WARD: Longford**94974/OUT/18****DEPARTURE: No**

Outline application sought for the demolition of existing retail unit and associated structures; erection of building for a mix of uses including: 433 apartments (use class C3) and communal spaces ancillary to the residential use; flexible spaces for use classes A1, A3, B1, D1, and/or D2; undercroft car parking; new public realm; and associated engineering works and infrastructure. Consent is sought for access, appearance, layout and scale with all other matters reserved.

Former B and Q Site, Great Stone Road, Stretford, M32 0YP

RECOMMENDATION: REFUSE

Figure 17. OS Map and Viewpoint / Receptor Location Plan (Source: Bing Maps)

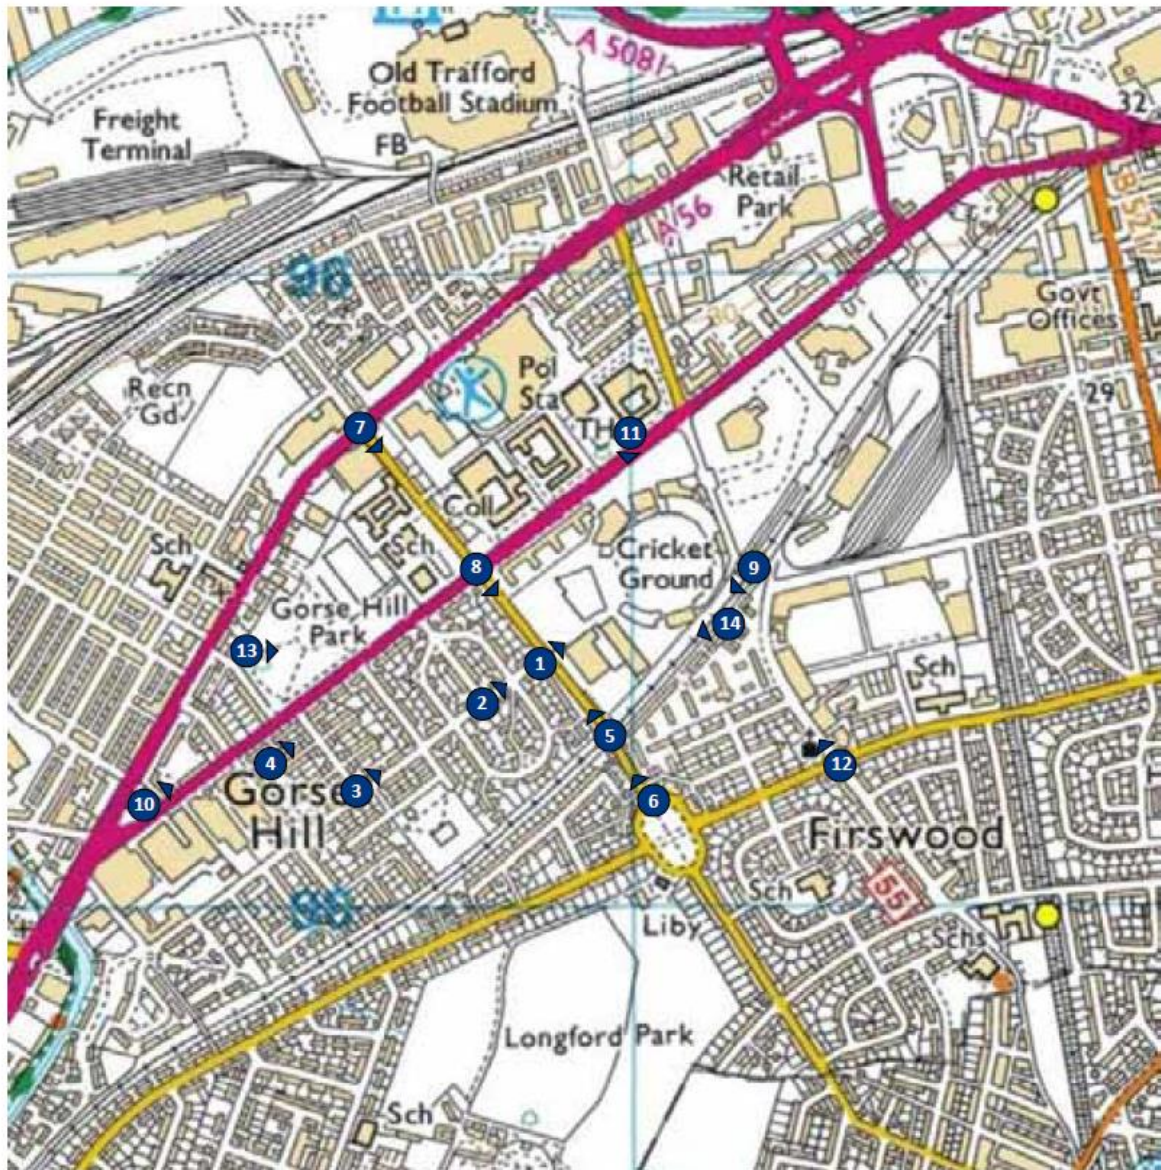
66. Fourteen wireframe viewpoints, the location of which can be seen at Appendix 1 were produced to inform the TVIA. The viewpoint images are included at Appendix 1.0 of the submitted TVIA. These viewpoints provide a visual representation of what the proposed development would look like from each viewpoint.

73. It is considered that the TVIA over emphasises the taller buildings to the north of the site and does not provide sufficient consideration of the larger proportion of the surrounding area which has a prevailing height of two storeys. It is also considered that the assessment of the effect of the proposed development on character has generally under-stated the likely scale of the development in

74. It is also considered that the predicted magnitude of change for some of the views has been understated and the use of landscape (rather than portrait photography) in visualisations has meant that the upper part of the building is not shown in some images. This gives an incomplete and inaccurate representation of the likely visual impact of the proposals. It should also be noted that 'Visual Representation 1' is not accurate as a large proportion of the building frontage is missing from the wireframe model.

Extract from Design and Access Statement

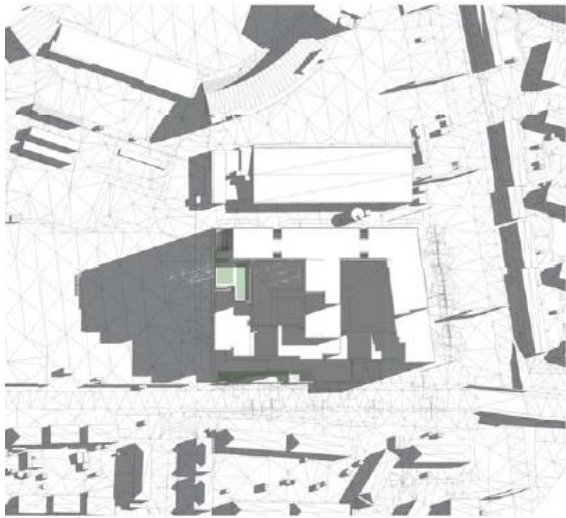
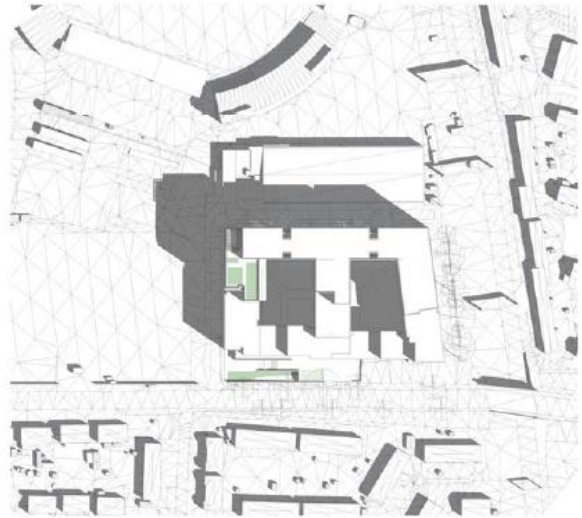
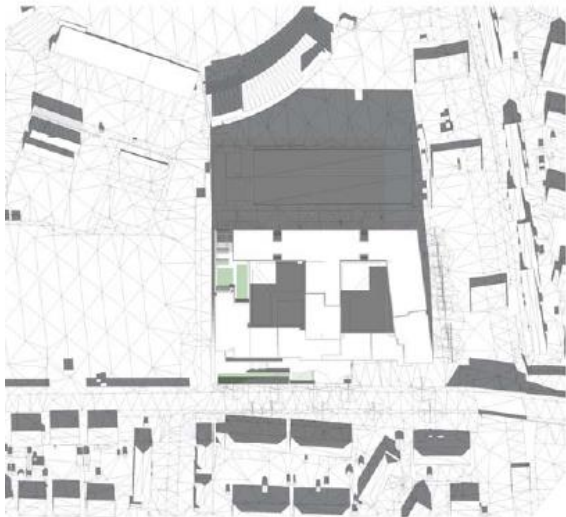
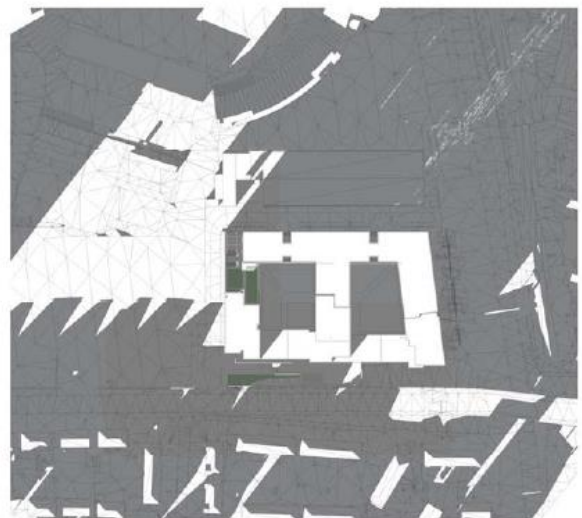
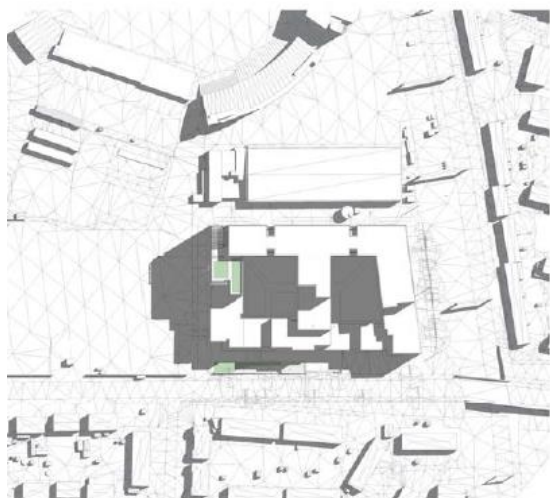
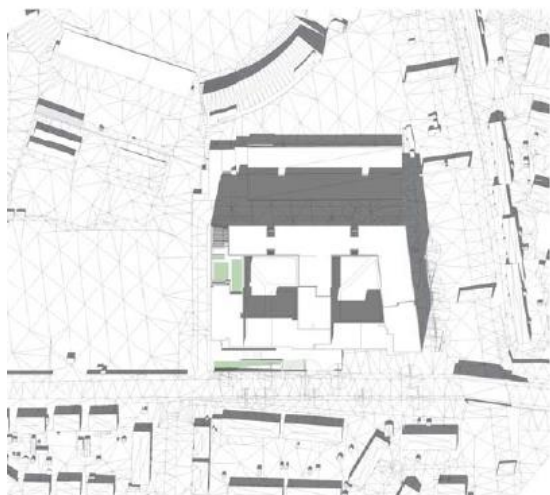
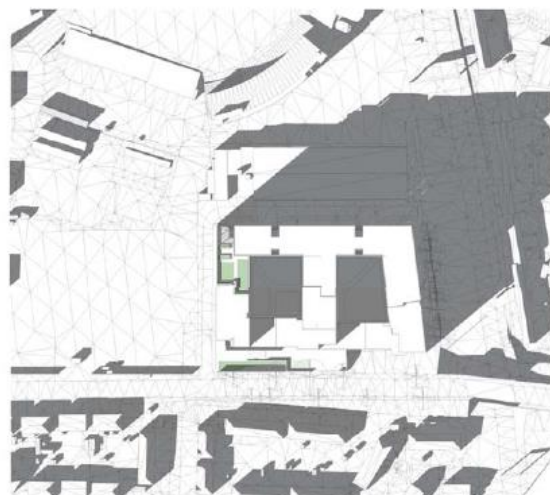
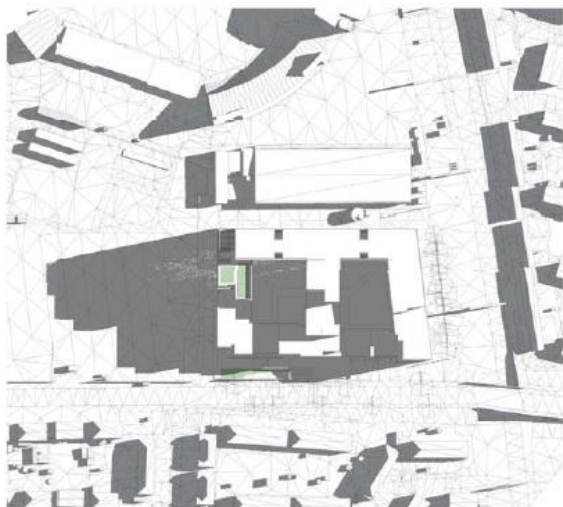
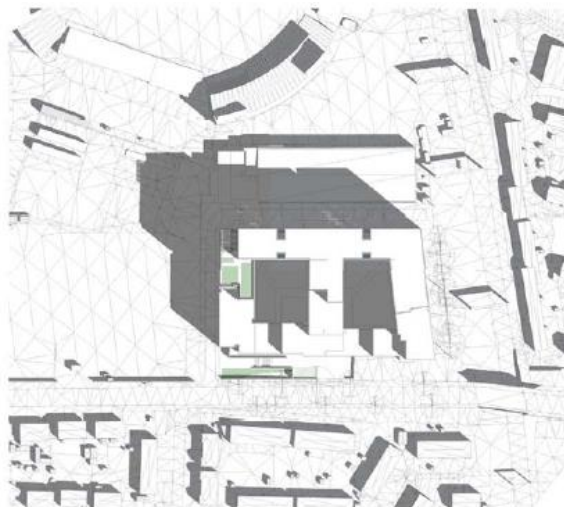
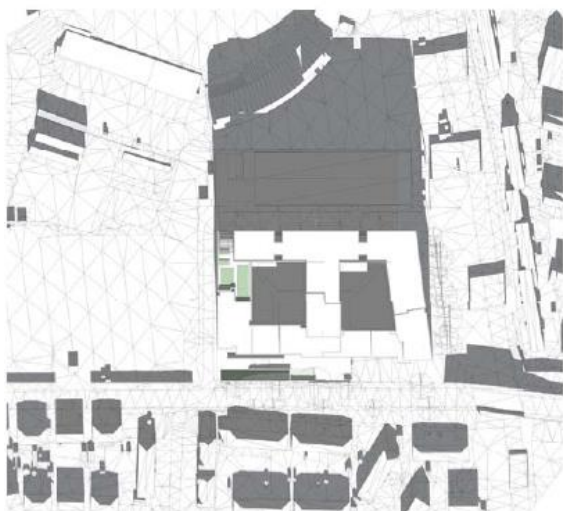
92. The layout of the site, combined with the height of the proposed development results in an overshadowing impact of the building on the internal landscaped courtyards. This is explored in more detail within the 'Amenity' section of this report, but is another indicator that the layout and scale of the proposed development is inappropriate.
